Pro Tools TDM 5.3 R4 Update for Pro Tools|HD (Macintosh Systems Only)

Addendum to the 192 Digital I/O and 192 I/O Guides

Figure 1. New Hardware Setup Dialog, with TDIF Word Clock checkbox

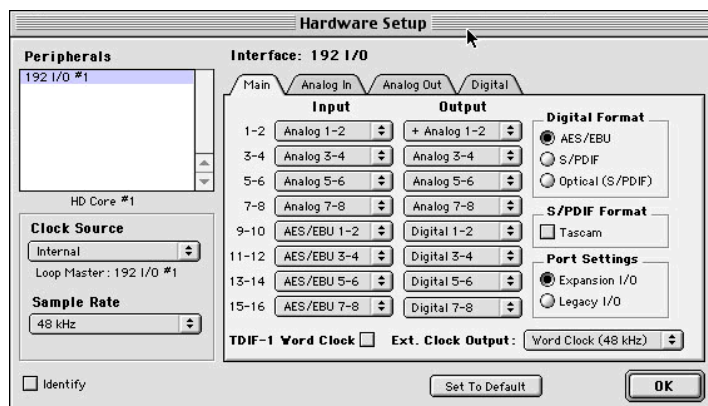
The Pro Tools Hardware Setup dialog now features a checkbox to support DA-88 and TDIF-1 word clock standards.

TDIF-1 Word Clock This checkbox changes the I/O's Word Clock output to conform to TDIF-1 word clock standards. This choice is only available when the session sample rate is 48 kHz or lower and when the Ext. Clock Output port (to the right) is set for Word Clock output.
